3 Volt Intel[®] Advanced+ Boot Block Flash Memory

28F800C3, 28F160C3, 28F320C3, 28F640C3

Specification Update

November 2002

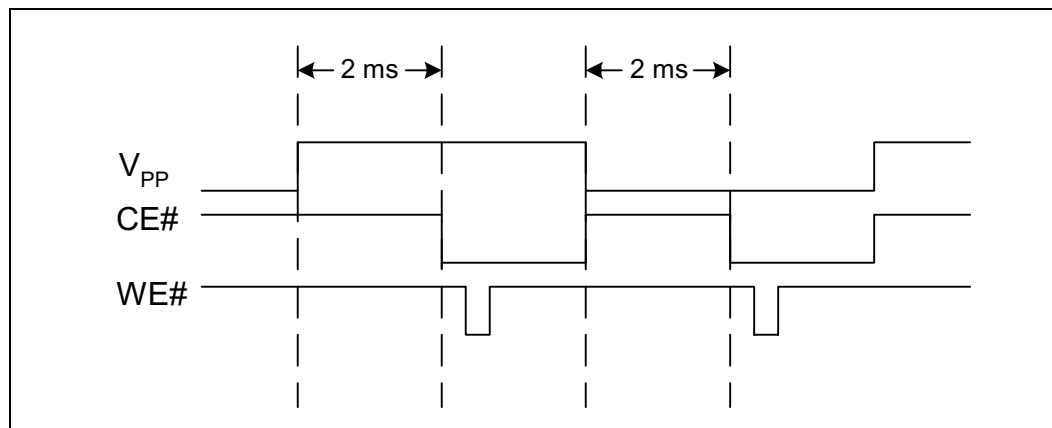
Problem: The 0.18 μ m 28F320C3xC devices can unintentionally reset under certain conditions where V_{pp} toggles.

Implication: When the reset occurs, any command being executed is interrupted and the flash switches to read array mode.

Workaround: There are four workarounds for this erratum:

- 1) Tie V_{pp} to V_{CC} ;
- 2) If the third and fourth digits on the top side FPO mark (third line) is equal or greater than “23”, then V_{CC} may be set from 2.7v to 3.3v. V_{CC} must not exceed 3.3v
- 3) Set V_{pp} to a static high or static low level as shown here; and

4) Wait 2 ms after a V_{PP} transition to access the flash device, as shown here.

Figure 1. Workaround Placement

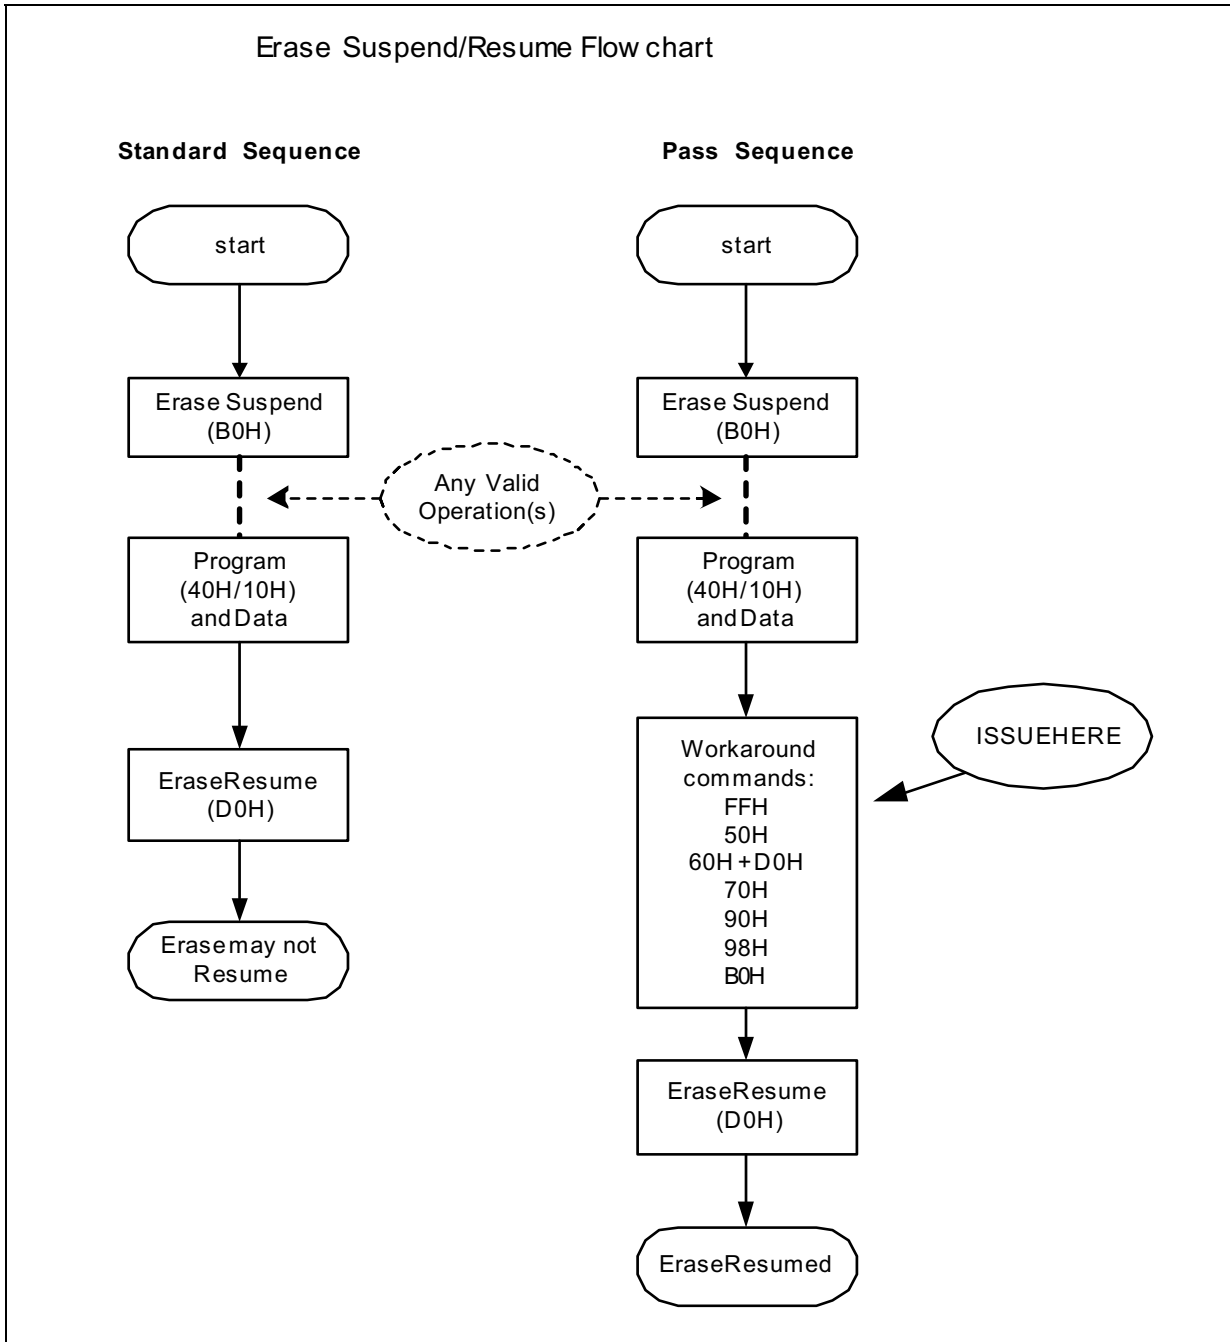
Problem: On the 0.18µm 28F160C3xC devices, a design anomaly was discovered. During an Erase-Suspend operation, if the Program (40H/10H) sequence is executed, under limited conditions the proceeding Erase Resume command (D0H) may not actually resume the device. No customers have reported failures in product applications. Customers who use any version of FDI (Intel Flash Data Integrator) software will not see this issue. If the Read Array command is issued prior to the Erase Resume command, users will not see the issue (typical in XIP applications).

Implication: The Resume Command (D0H) may be ignored by the device and will not correctly resume. The device will appear to remain in suspend (via status register). After a reset of the flash device the status register will clear. This failure has been recreated in a lab environment only.

1. If FDI (Intel Flash Data Integrator) software is used, users will not see the issue.
2. During an Erase-Suspend (B0H), user must issue any of the following commands after issuing the Program (40H/10H) and data sequence but before issuing the Erase-Resume (D0H) command.

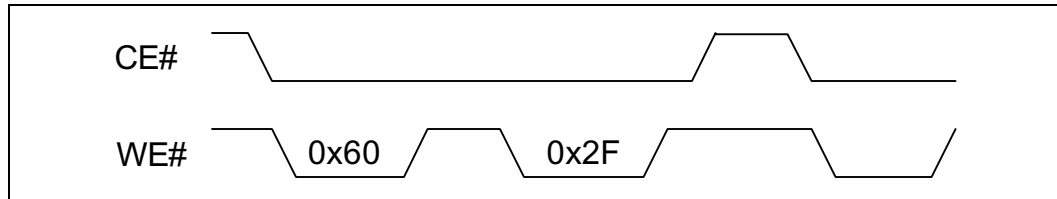
Problem: On the 16Mb and 64Mb 0.18µm devices, if CE# is deasserted after any block lock operation and before the next write sequence, the part may perform the same operation on additional blocks. (See waveform below.)

Implication: When CE# is deasserted after performing a block lock operation to a specific block and prior to the next write sequence, other blocks may perform the same operation.
